**OFFICE OF NEW REACTORS**

**ASSESSMENT OF WHITE PAPER SUBMITTALS ON  
DEFENSE-IN-DEPTH; LICENSING-BASIS EVENT SELECTION, AND SAFETY  
CLASSIFICATION OF STRUCTURES, SYSTEMS, AND COMPONENTS  
(REVISION 1)**

**NEXT GENERATION NUCLEAR PLANT  
PROJECT 0748**

**Figure 1. Proposed dose acceptance limits for the NGNP safety analyses  
(Source: Figure 3 in the NGNP LBE white paper)**

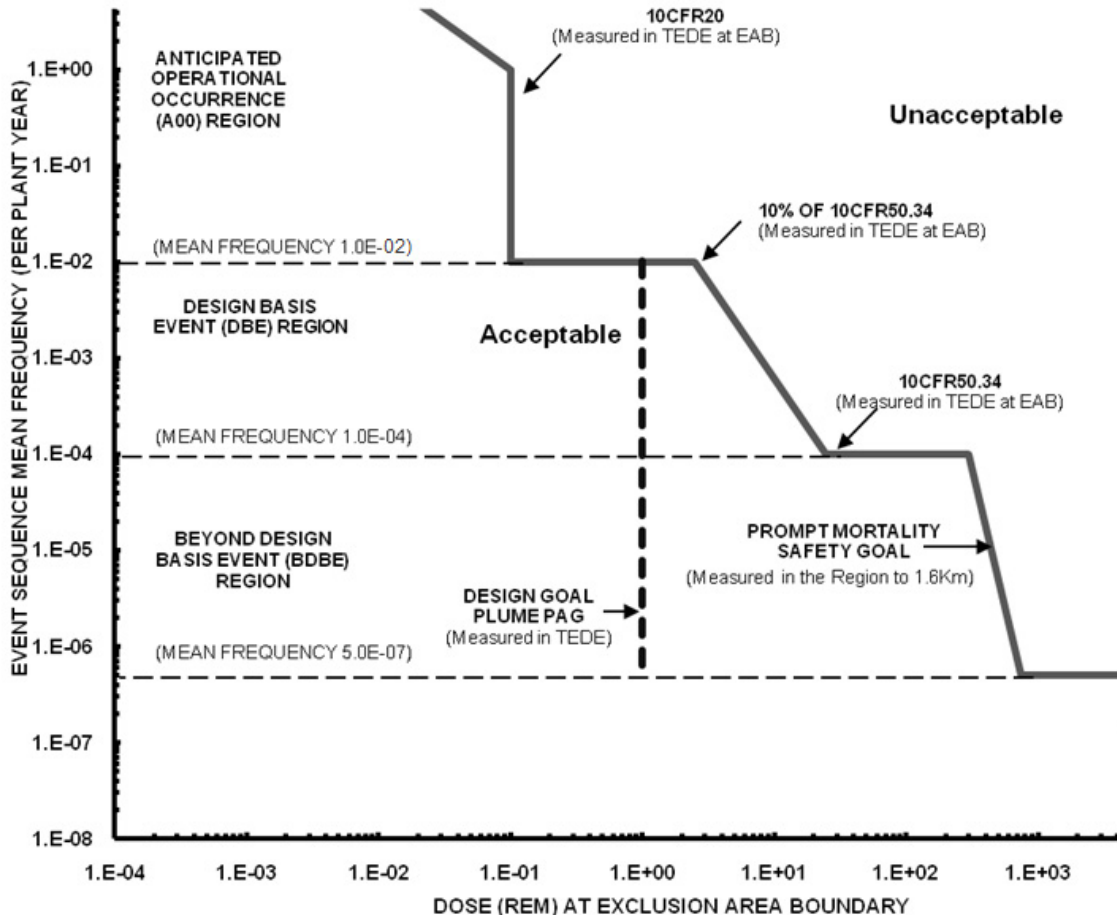
DOE/INL proposes dose acceptance limits on the LBE consequences and the analysis basis for the LBE categories, which are generally consistent with the NGNP Licensing Strategy with several significant exceptions. Figure 1, a reproduction of Figure 3 from the NGNP LBE white paper, depicts the proposed dose acceptance limits for the NGNP safety analyses.

The event frequency versus dose consequence acceptance line shown in Figure 1 is generally referred to as an "F-C curve." For events in the AE frequency region, construction of the proposed F-C curve is based on the dose limits in 10 CFR Part 20. For events in the DBE frequency region, construction of the proposed F-C curve is based on the dose limits in

10 CFR 50.34.<sup>7</sup> For events in the DBE region, the proposed F-C curve has been constructed in such a manner that would reduce the dose limit as DBE frequency increases. For the DBAs (which are selected and derived from the DBEs), DOE/INL proposes that dose criteria in 10 CFR 50.34 apply (i.e., without reduction). For events in the BDBE frequency region, construction of the proposed F-C curve is based on the prompt mortality safety goal. DOE/INL proposed that the dose limits be associated with, and apply at, the NGNP EAB.

The overall construction of the proposed F-C curve generally follows an iso-risk curve to allow low doses for relatively frequent events and higher dose limits for rare events. The intent of the construction of the F-C curve is to ensure that the overall NGNP risk for all LBEs combined will meet the NRC's safety goals.

The staff recognizes that there are a large number of ways to construct an F-C curve that use the dose acceptance criteria of existing NRC regulations and applies them to inferred frequency ranges for the event categories to meet the above stated objectives. For example, the proposed frequency consequence curve shown in Figure 3-3 in NUREG-1860 was developed in connection with the NRC staff's feasibility study for a risk-informed and performance-based regulatory structure for future plant licensing. The development of the F-C curve shown in Figure 3-3 of NUREG-1860 was done using the same LWR regulations that DOE/INL used to develop its proposed F-C curve. The development of the F-C curve in NUREG-1860 also includes consideration of additional dose acceptance criteria associated with national and international radiological health standards.
